# RESPONSE TO CUMBERLAND DESIGN EXCELLENCE PANEL COMMENTS – DA2020/0542

14–22 MARY STREET,  
AUBURN

## Response to Cumberland DEP Issues - 14-22 Mary Street, Auburn

Option A - Side entrance

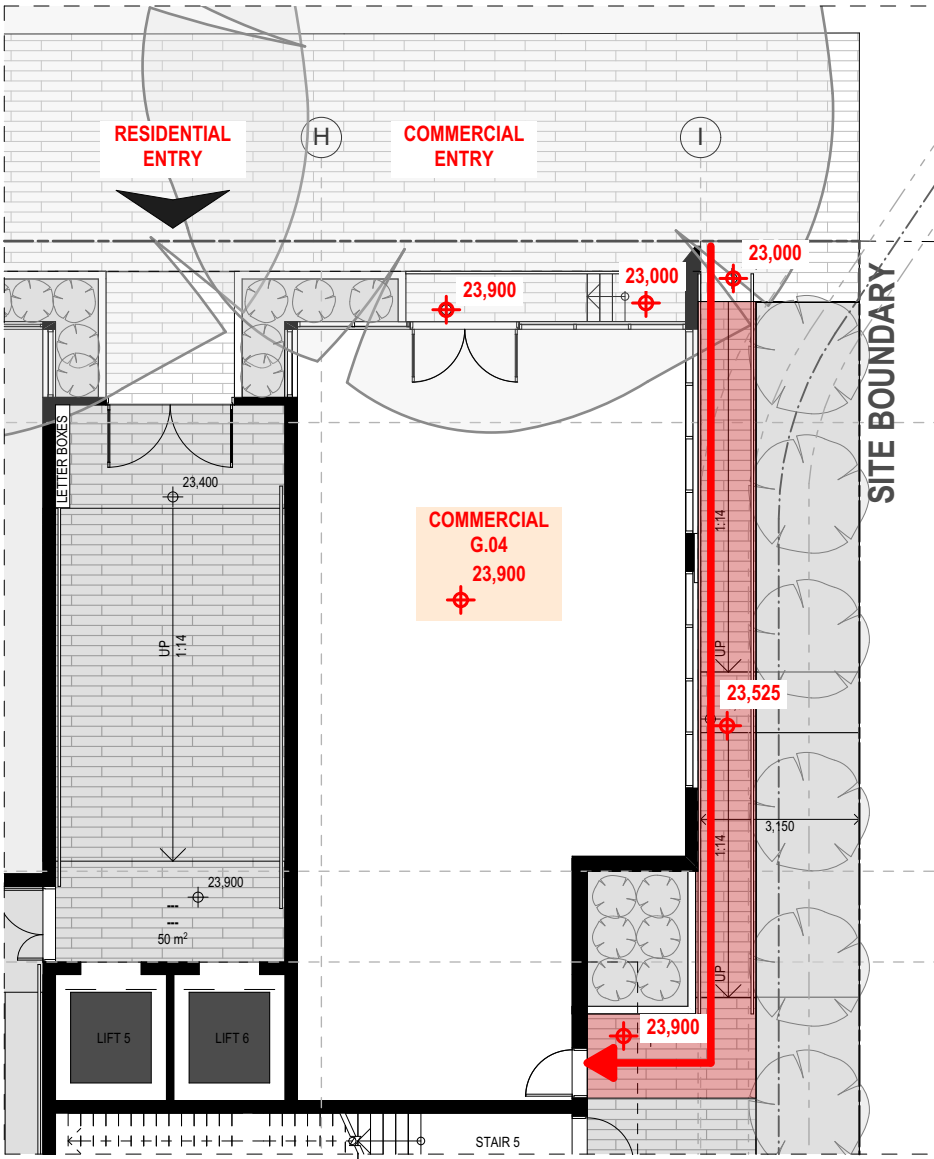
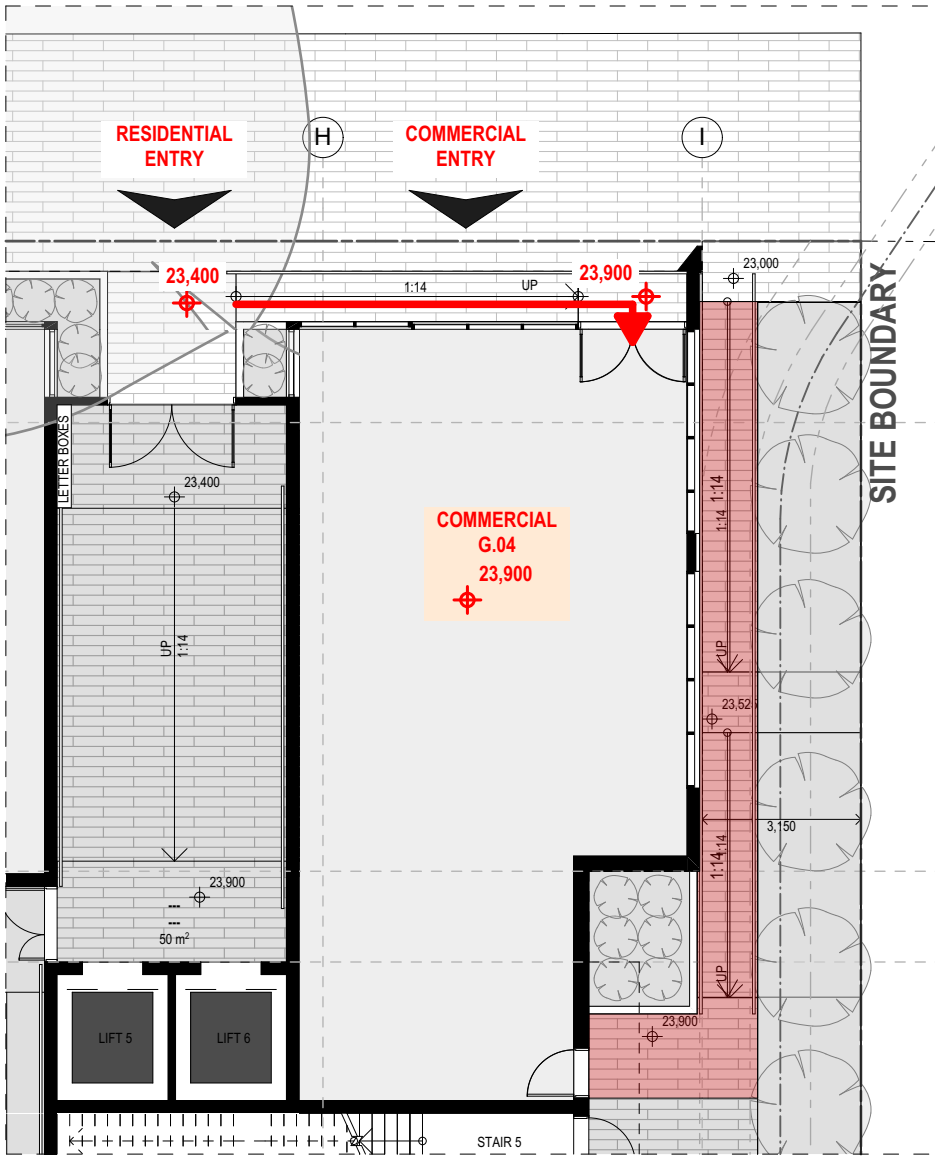
3C Public domain interface – generally satisfactory however no accessible path to the commercial G04 space is provided and the proposed stair at the street is not an ideal interface with the public domain.

An accessible path has been provided to Commercial Unit G.04.  
Please note that there are 2 options for access to the tenancy. The DA shows option A.

Accessible Path to the Commercial G04 is highlighted in red on Ground Floor Plan 01.  
The commercial G.04 floor level is at RL 23.900 to accommodate the existing flood level.

The steps are removed and an accessible path is provided to the front of G.04 on Mary Street.  
The commercial G.04 floor level is at RL 23.900 to accommodate the existing flood level.

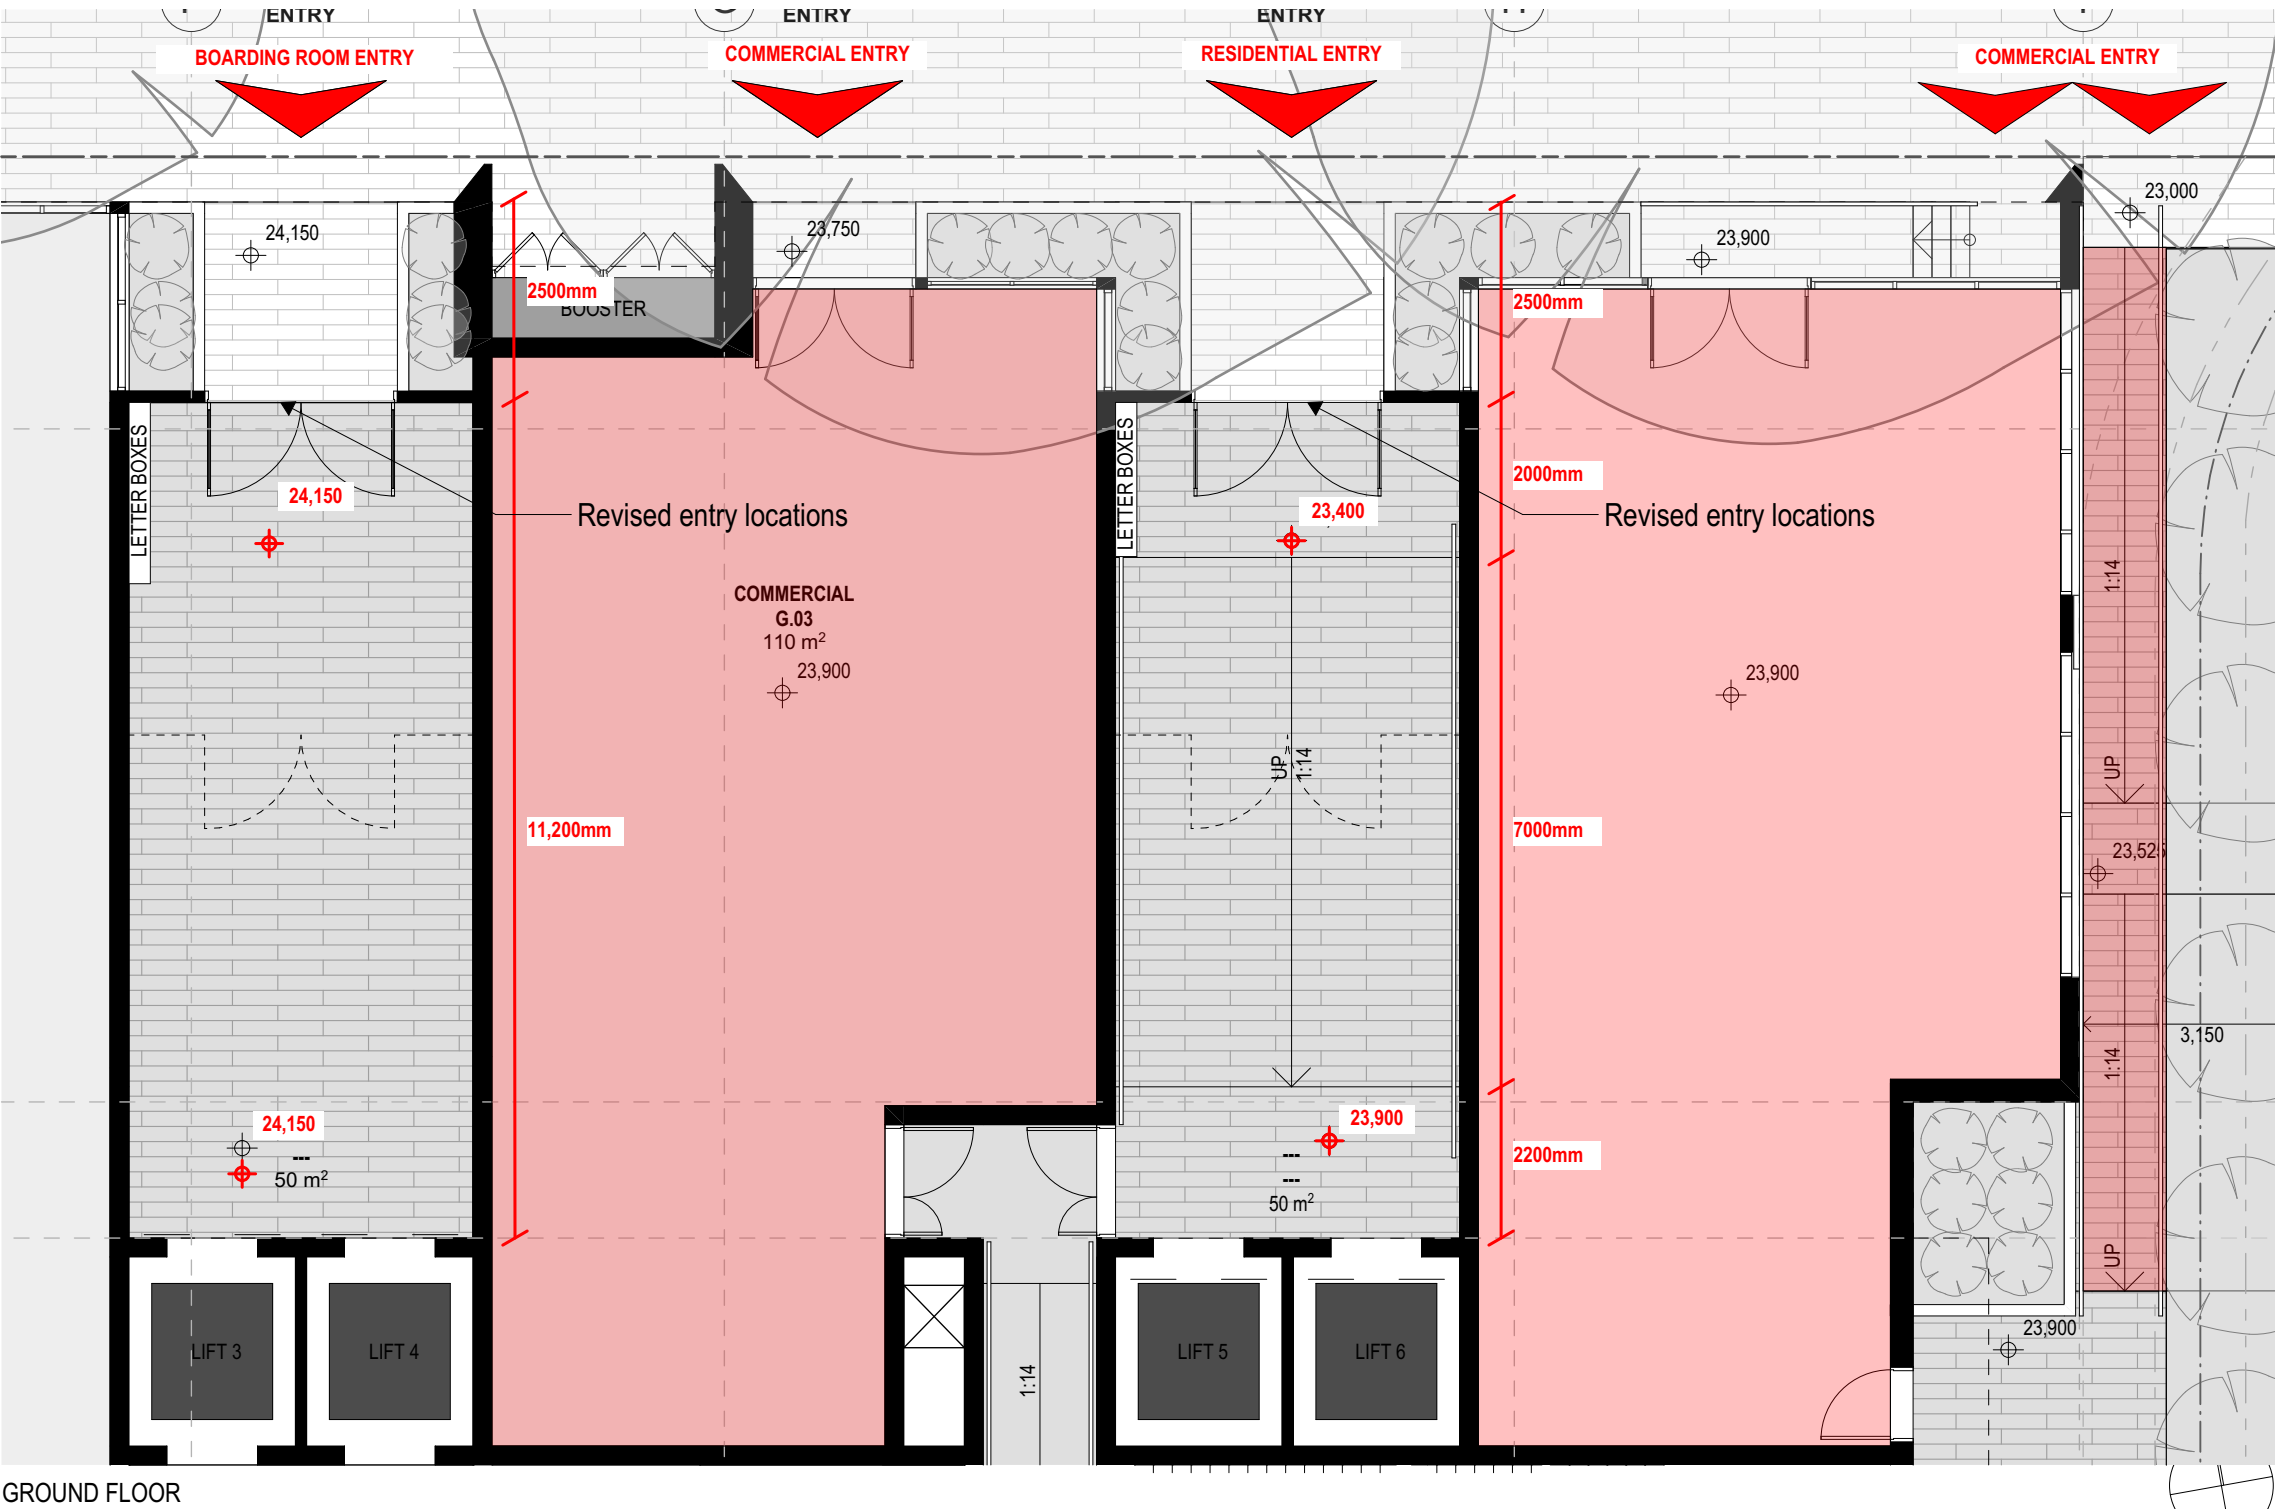
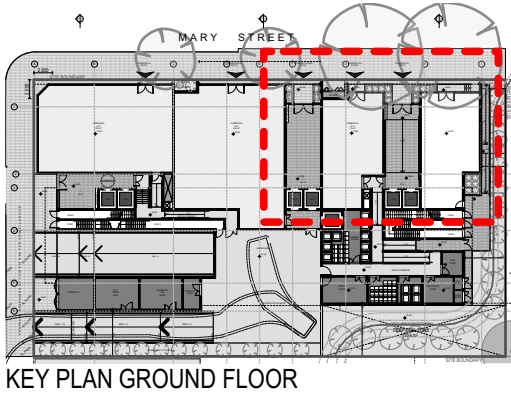
3C Public domain interface – generally satisfactory however no accessible path to the commercial G04 space is provided and the proposed stair at the street is not an ideal interface with the public domain.

"apartment entries are deeply recessed and concealed from street and may be unsafe - apply CPTED design principles and bring front door to street."

Boarding house and Residential entries have moved forward to the boundary to comply with CPTED design principles.

KEY PLAN LEVEL 5-9

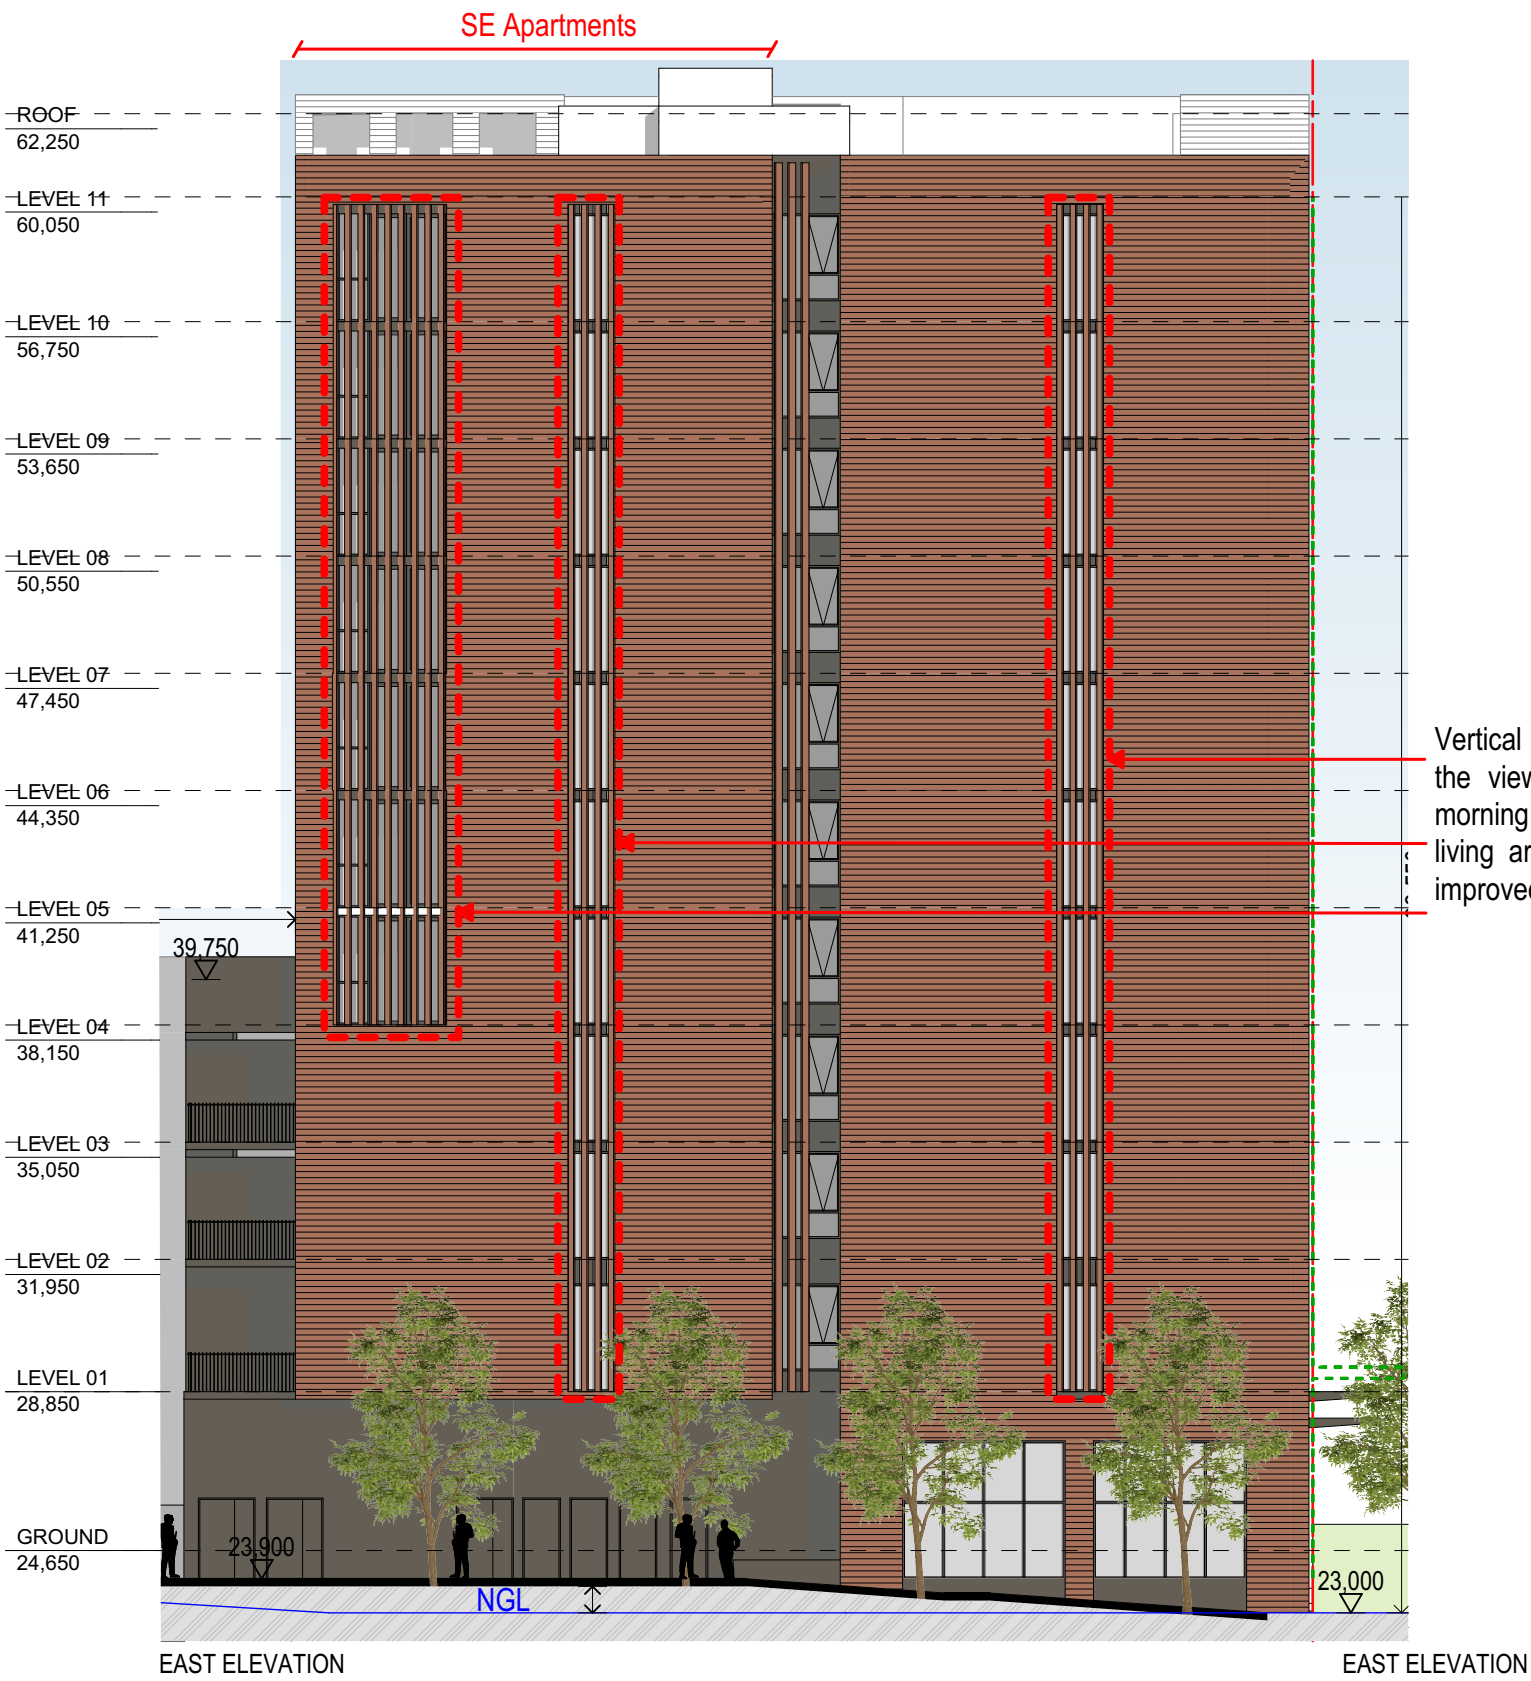
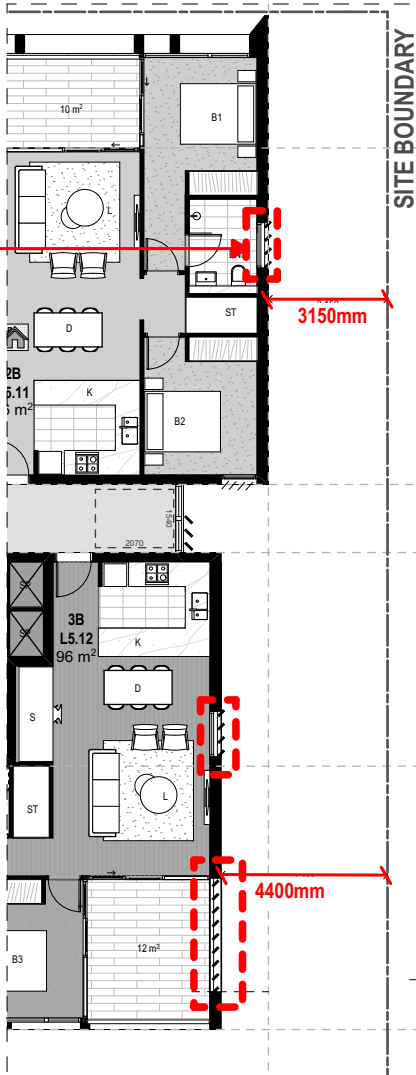
e. **Principle 6: Amenity 3F Visual Privacy**  
The proposal does not comply with the required setbacks as follows:

f. **Principle 6: Amenity**  
Whilst the 7 SE corner apartments are not assumed by the applicant to achieve the required solar access, they do not get any solar access to their balconies and only minimal sun to their living areas. The applicant should be requested to modify the plans to allow improved solar access to these apartments whilst maintaining privacy to the site to the east.

Privacy screens added to the SE apartments.

Vertical louvers used to screen the view yet angled to allow morning sunlight into the S/E living areas and balconies for improved solar access.
